NOISE FROM THE FRONT SEATS WHEN ADJUSTING THE SEAT LENGTH

F06 (6 Series Gran Coupe)	F12 (6 Series Convertible)	F13 (6 Series Coupe)
---------------------------	----------------------------	----------------------

Replace left or right seat rail (9 FRU)

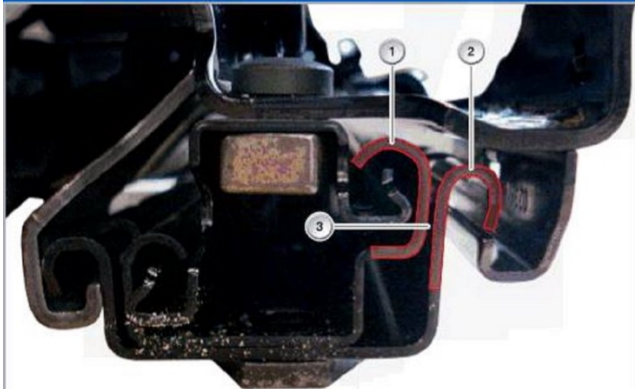
The seat rail is not smooth over its entire length.

2. In addition to the lubrication points indicated in the Repair Instructions, apply lubricating grease (3) BETWEEN the reinforcement plate (1) and the outer shell (2).
---	---
